寄件者: ip_ken <[REDACTED]>
寄件日期: 2026年02月27日星期五 15:38
收件者: Jason Sek Hei WONG/PLAND
副本: lao_fionne; Travis Tsz Ki KWOK/PLAND; Athena Pui Yin LAI/PLAND; Yen PY LEUNG/PLAND
主旨: 回覆: [Departmental Comments] Planning Application No. A/YL-SK/445 - Temporary Logistics Centre and Workshop for a Period of 3 Years
附件: 給規劃署的回覆.pdf; A_YL-SK-445_DIA+DRAINAGE PROPOSAL-REV A申請報告(2).pdf; 211119___AS BUILT RECORD 排水圖.pdf
類別: Internet Email

I refer to the planning application No. A/YL-SK/445 for Temporary Logistics Centre and Workshop for a Period of 3 Years at Lots 580 (Part), 595, and 598 S.B. (Part), D.D. 114, Wong Chuk Yuen, Shek Kong, Yuen Long.

DRAINAGE IMPACT ASSESSMENT & DRAINAGE PROPOSAL

**Proposed Temporary Logistics Centre for 3 Years
at Lot Nos. 595, 580(part) and 598(part)
In D.D. 114, Yuen Long, NT**

**PROPOSED TEMPORARY LOGISTICS CENTRE FOR
3 YEARS AT LOT NO. 595, AND LOT NOS. 580 (part) + 598 (part) IN D.D. 114
SHEK KONG, YUEN LONG, NEW TERRITORIES**

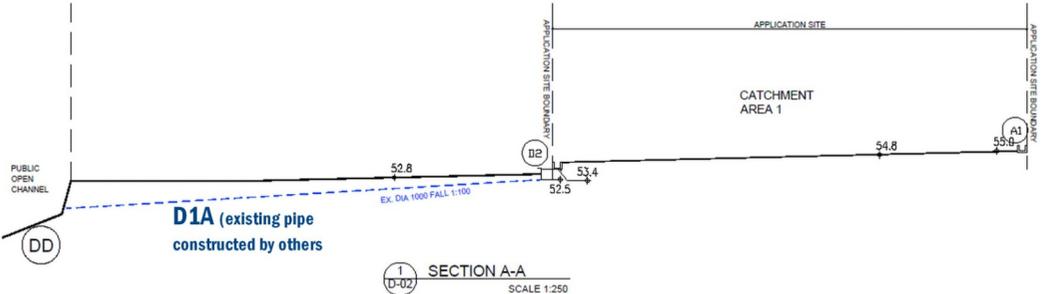
DSD's Comments for CASE – para. (e)	Response to Comments
<p>Catchment Area 1 (Lot 595) & 2 (Lots 580 part & 598 part)</p>	
<p>i) application areas were formed slightly higher; to provide section to show flow of peripheral areas (before & after site formation); and drainage pipe shall consider taking care of flow of peripheral areas</p> <p>ii) - to show catchpit/manhole CL and IL and pipe IL.</p> <p>iii) - to indicate Cross sections (A-A, B-B) marks on plan; - to verify section B-B and flow levels / directions and review according to site setting.</p> <p>iv) - to provide connection details of 2 DN1000 pipes</p> <p>Note: D1A - 1000 diameter pipe to connect village channel D2 and drainage discharge of AREA 1 (Lot 595).</p>	<p>i) - Lot595 - refer revised section A-A, which now shows peripheral upper grounds; plan now show catchment area flow pattern; - Lot 580(part), 598 (part) – refer revised section B-B, please note that formed levels are raised, and runoff from site mainly discharge to DD via D1 (1000 mm diameter pipe); but east edge peripheral area will flow towards south to lower grounds</p> <p>ii) CL/IL for catpit / manhole / pipes are shown on revised Drainage Layout Plan</p> <p>iii) - section marks are shown on revised drainage layout plan; - levels of site, and pipes are checked and revised</p> <p>iv) please refer to photos of construction of D1; D1A is an existing pipe constructed by others a few years ago and construction of which has no photo record, profile section is as follows:</p>

Photo 1 CONDITION OF STREAM D2 (OUTSIDE SITE), AND A1B OF SITE

THE STREAM CONNECTS TO UNDERGROUND DRAIN D1A OF 1M DIAMETER

DRAIN A1, A1B, SANDTRAP ST1, AND DISCHARGE TO VILLAGE DRAIN D2

Photo 2 Condition of LAST MANHOLE ST1, and discharge at D1A (1m diameter)

Photo 3 Condition of Drain DD, natural village stream

CONSTRUCTION RECORD OF DRAIN D1 - 1M DIAMETER SERVES ONLY FOR LOT 580 (PART) AND LOT 598 (PART)

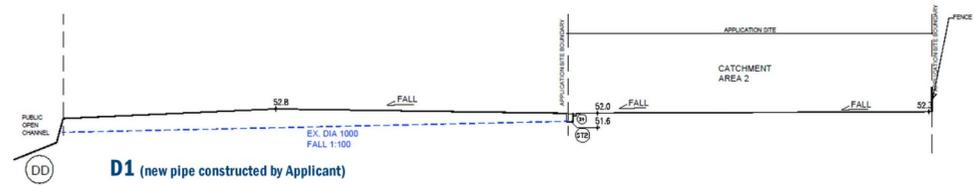
iv) - to provide connection details of 2 DN1000 pipes (cont'd)

D1 - 1000 diameter pipe to collect drainage discharge of AREA 2 (Lot 580 & 598 part).

D1 is **new 1000 diameter pipe constructed by the Applicant** with falls and levels:

D-01A

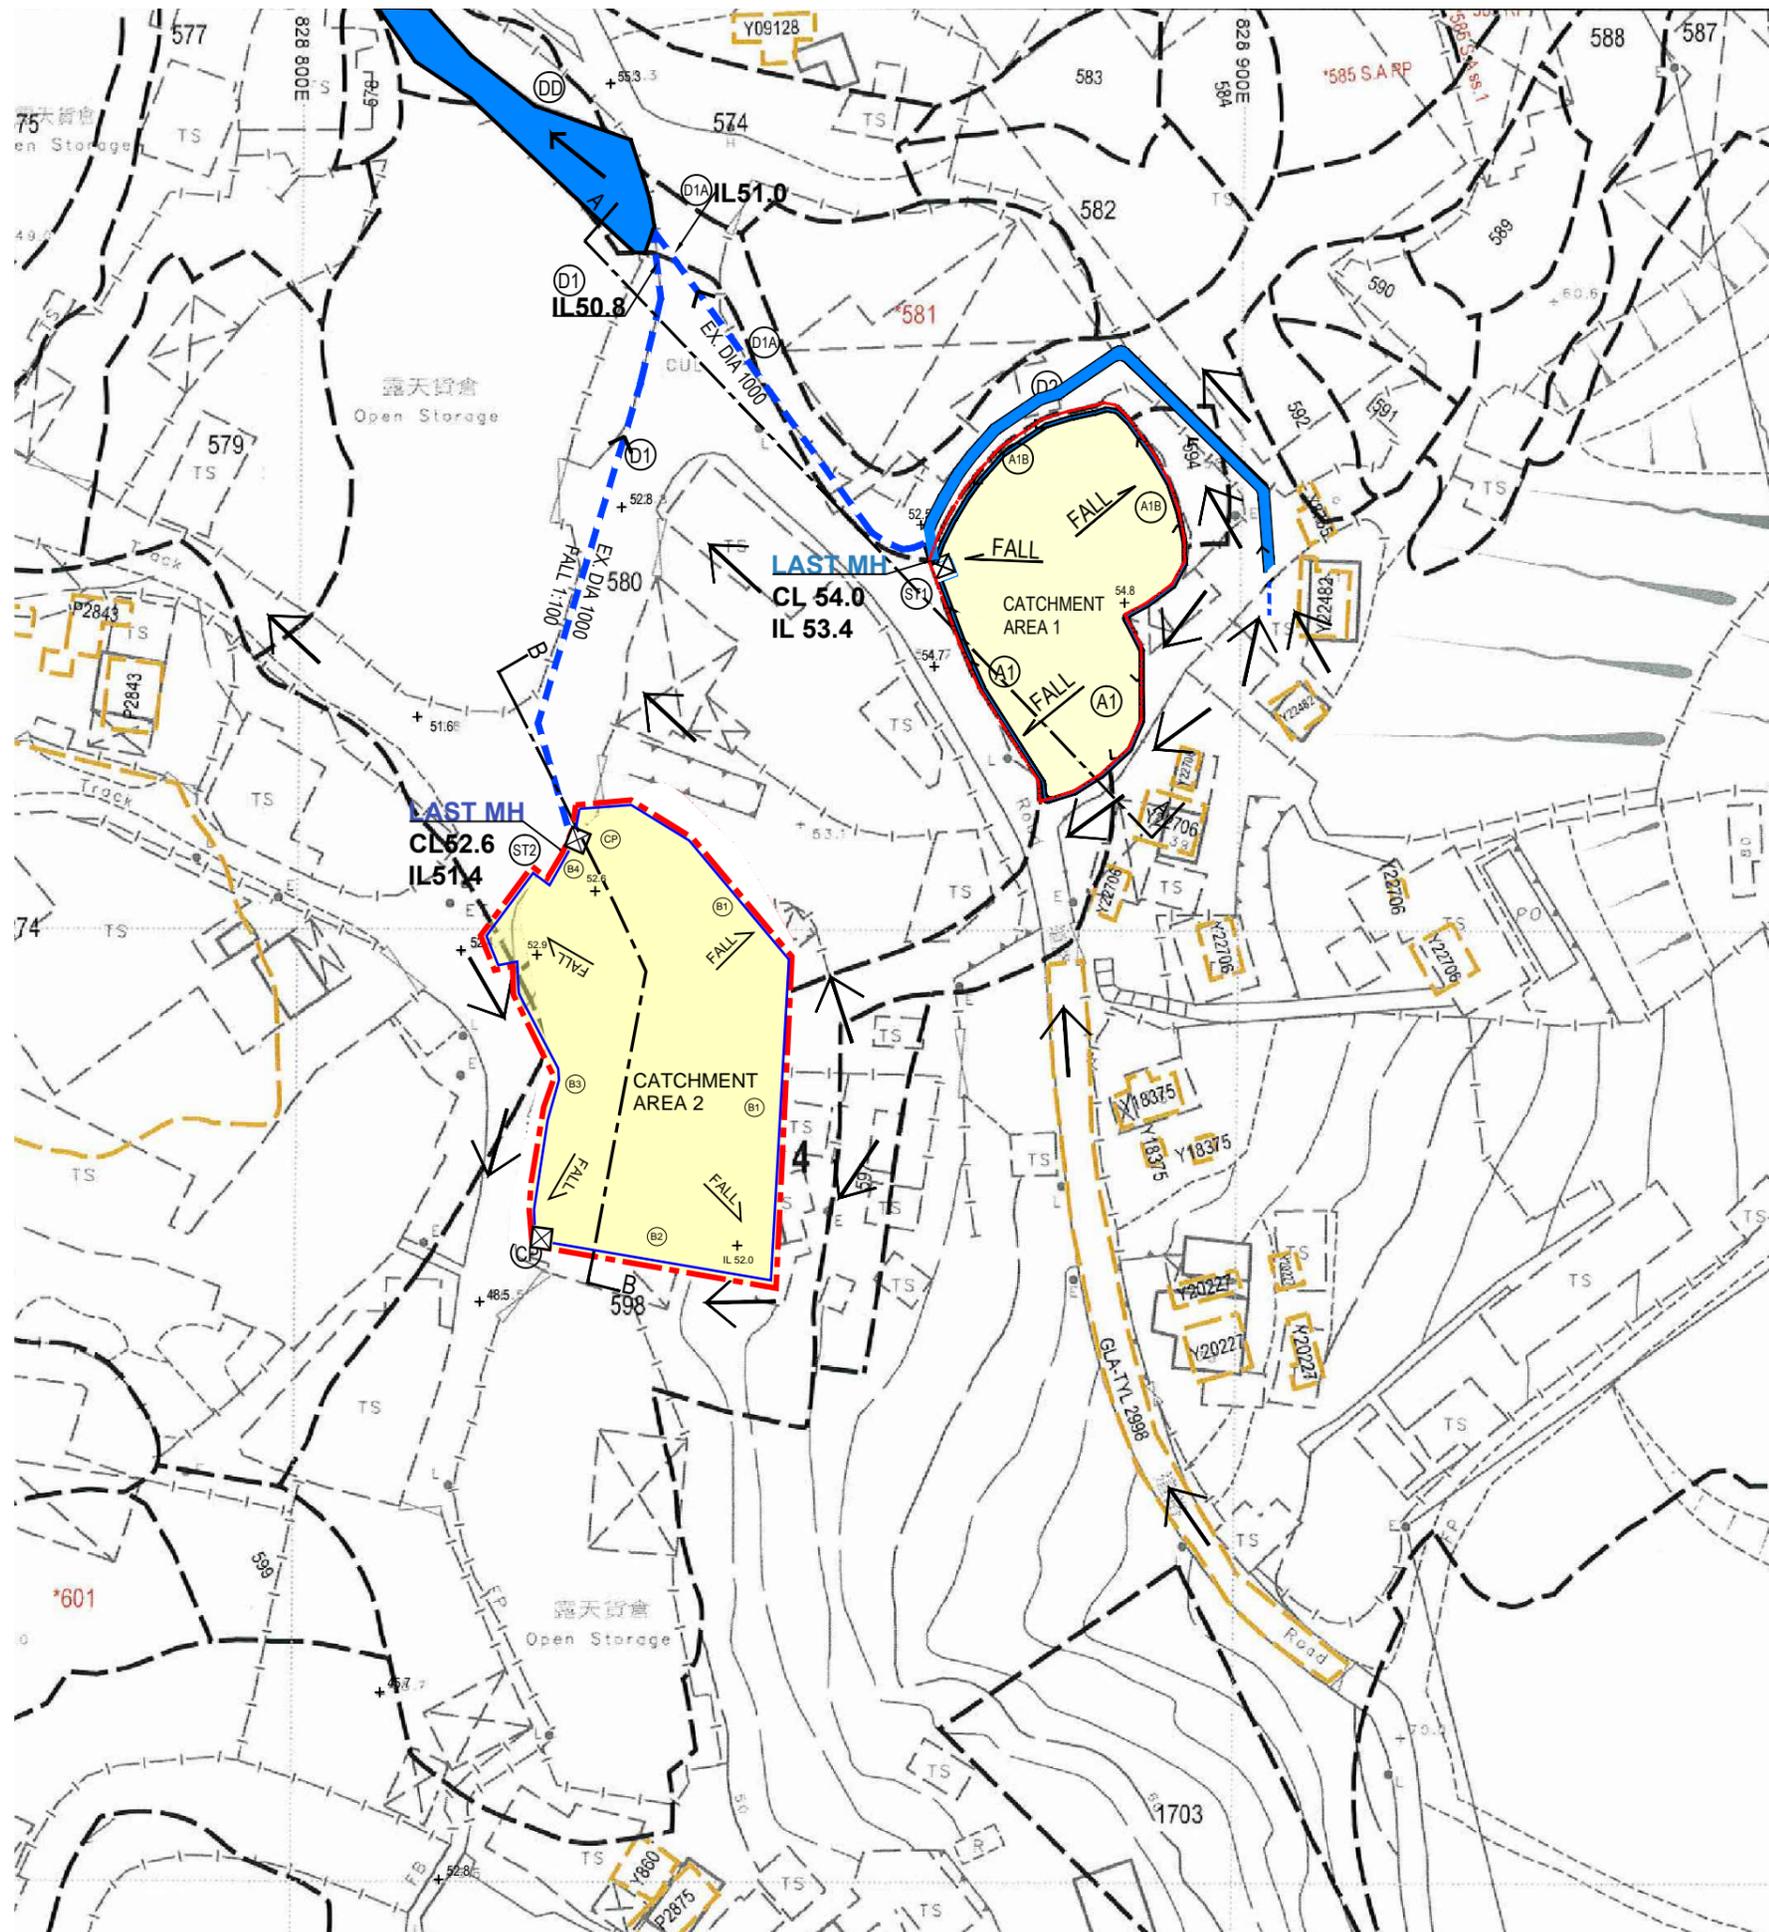
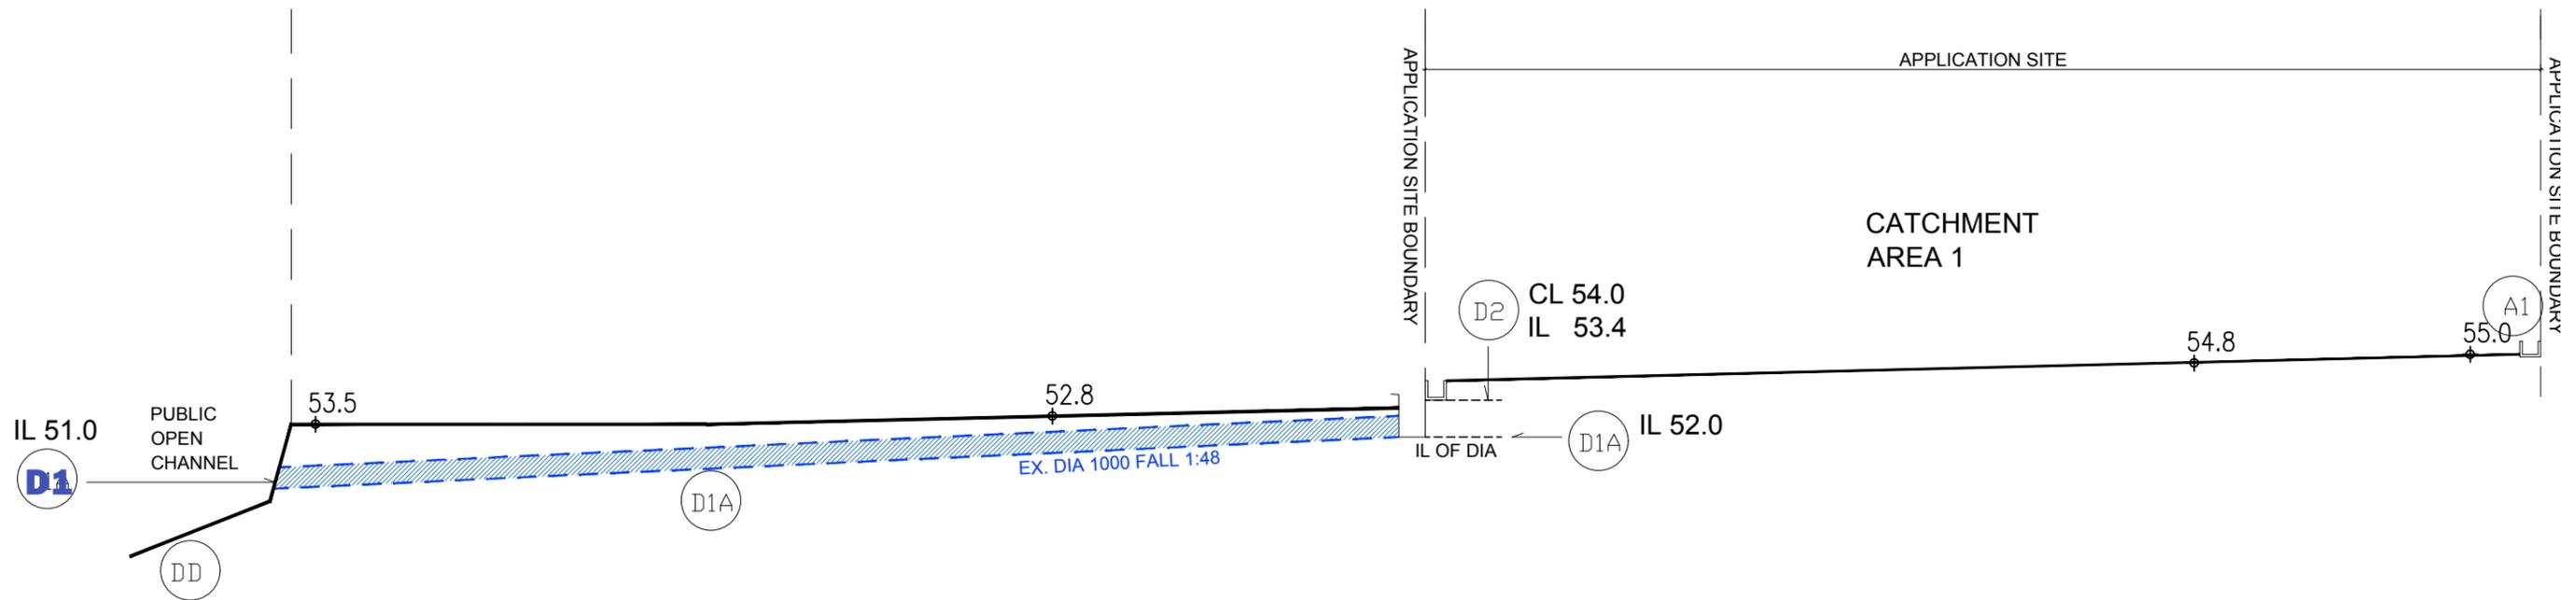
v) - to clarify sizes of B2, B3

vi) - to show flow pattern of peripheral upper ground flow

v) sizes of B2, B3 shown on drawing

vi) please refer sections A-A, B-B and revised drainage layout plan showing more levels and flow pattern
